62-F-272 M
C-12-17 CULVERT
SHASHAWANDAM
CREEK
BOSANQUET
TWP

STRUCTURE SITE No. 15-287
 DA 1516
 ROAD CULVERT C-12-17
 SHAWANA CREEK BRIDGE
 RD #12 ST. 37-80 PL NO R 24-2
 Drawn: O-D Traced
 COUNTY OF LAMBTON Appr. [Signature]
 ENGINEERING DEPT. Date: Sep 24/02
 County Eng. Brian Devereux Scale: as noted
 PL NO. B-40

Mr. A. G. Stermac,
Principal Foundation Engr.,
Foundation Section,
Materials & Research Division.
October 25, 1962.

Soils Report by E. M. Peto Assoc., Ltd.
County of Lambton,
Proposed Pipe Culvert,
Township of Bosanquet,
Lot 62, Rd. between L.F.E. & L.R.W. Cons.,
Structure Site #15-287.
Bridge Office Ref. #BA 1516.

ILLUSTRATION OF STABILITY ANALYSIS

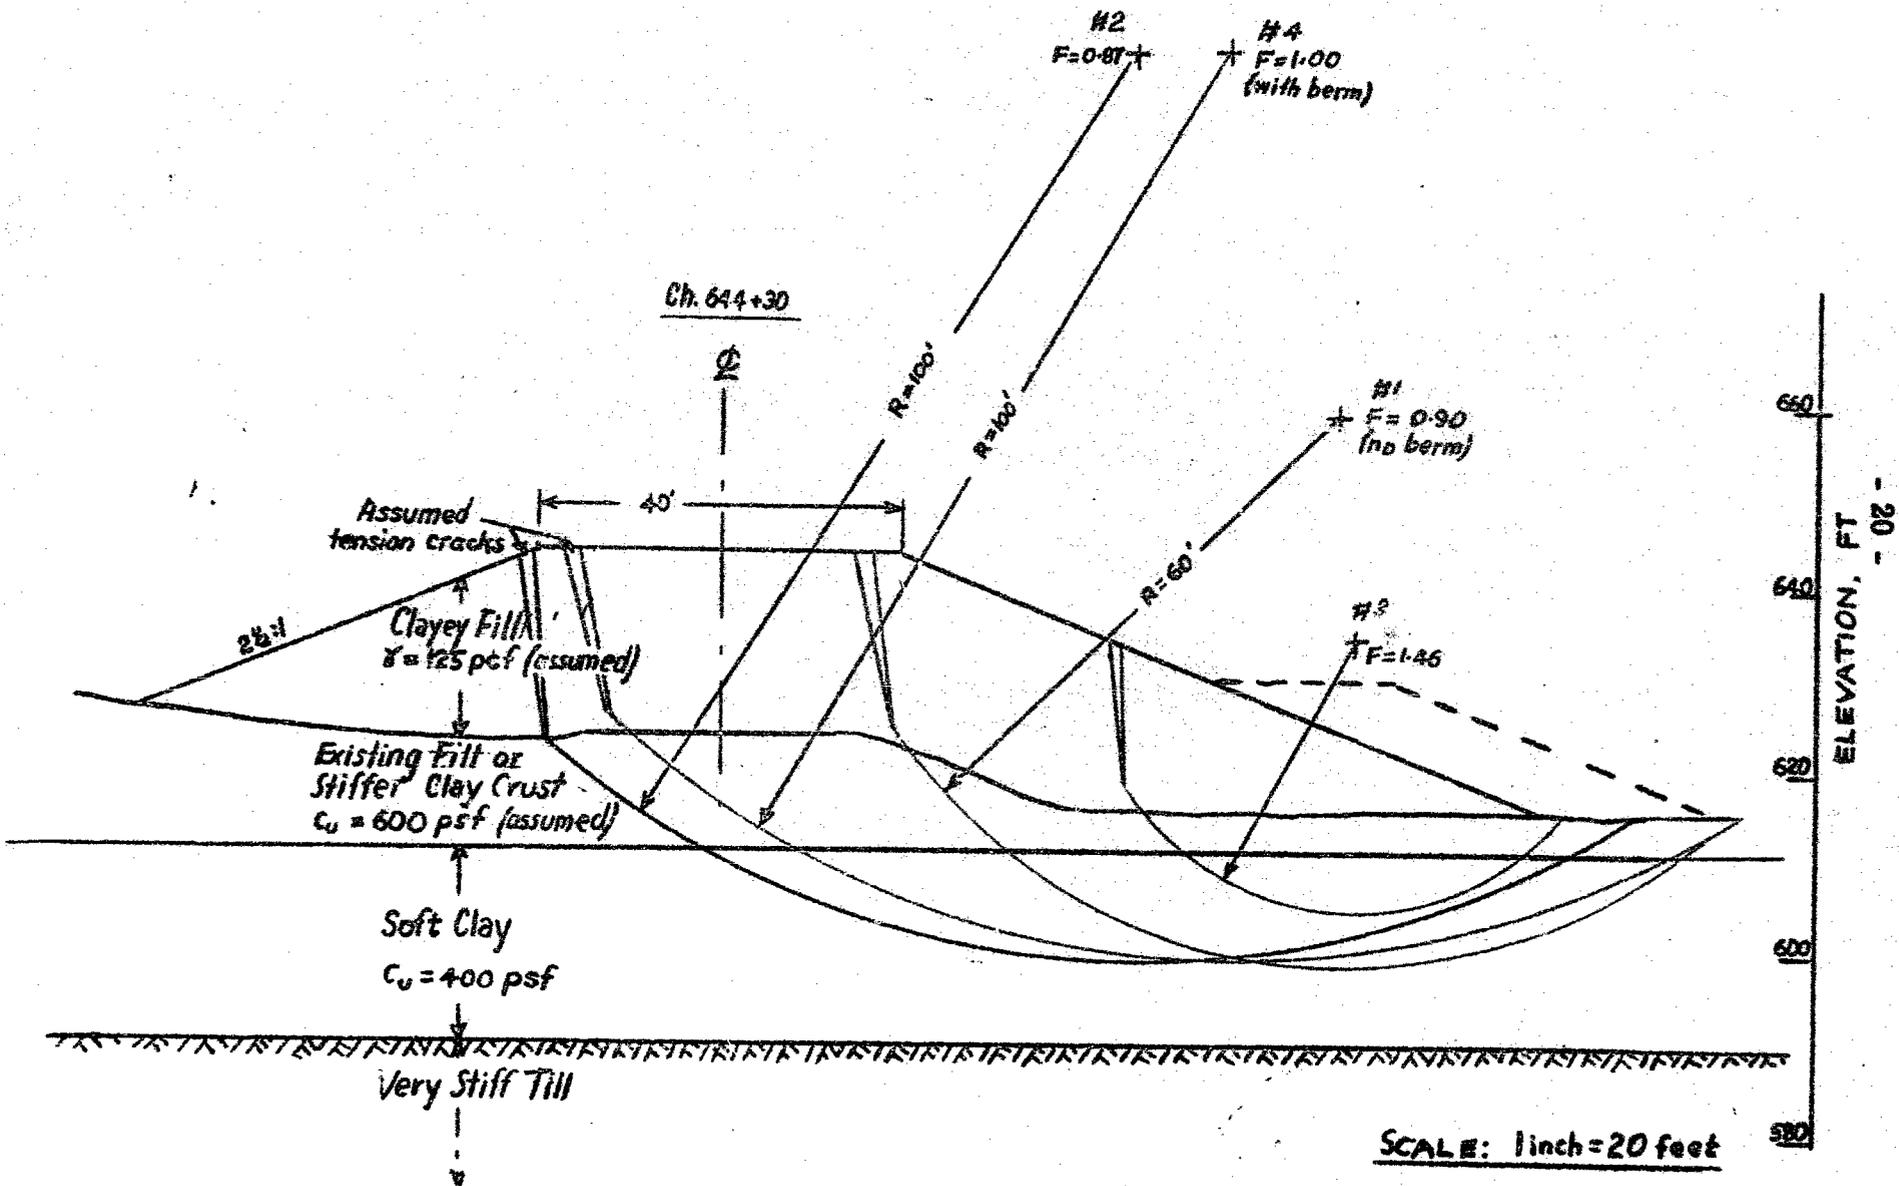
To resolve these two problems, the shear strength as well as the compressibility characteristics of the soft clay, have to be reliably determined. In evaluating the results of unconfined compression tests, the consultant has discarded all the low values on the ground of probable sample disturbance. An average of the higher values of 400 p.s.f., was then used in the stability analysis. The results of the analysis show that the fill is unstable. A 20-ft. berm increases the factor of safety only to one.

The shear strength is the governing factor in the analysis. Unfortunately, this is also the item of uncertainty in the report. Based on the "factual" information as contained therein, we have therefore, to take them as "reliable" values on which to base our judgment.

It would appear to us that a logical conclusion based on the results of the field and laboratory investigation and the subsequent analyses, would be the recommendation of a berm which would assure the stability of the structure.

However, the consultant is of the opinion that an embankment failure is not likely to occur, and in view of the minor importance of the road and the cost of measures to increase the embankment stability, he thinks that the risk of having a failure is warranted. The consultant bases the above statement on the uncertainties involved in the stability analysis and its consequent limited reliability, and also the probable presence of a stiff upper crust.

We can hardly agree with such a choice. It is our opinion that however limited or extensive an investigation is, it should produce results that are reliable. Factual information should be beyond doubt. Therefore, we think that the two boreholes should have revealed, and the subsequent lab. investigation accurately established the type and properties of different soil layers. From the presented information - and if this information can be considered reliable - there is no upper crust in B.H. #1. It also appears reasonable to assume that no crust is present in the creek bed. This would then represent the most unfavourable condition and therefore the basis for the stability analysis.

With respect to the consultant's reference on the reliability of the stability analysis, there is ample evidence both in the literature and from our experience, that such analyses have produced reasonably accurate results provided that the relevant soil properties are reliably determined. However, it seems that the consultant has little faith in his results.
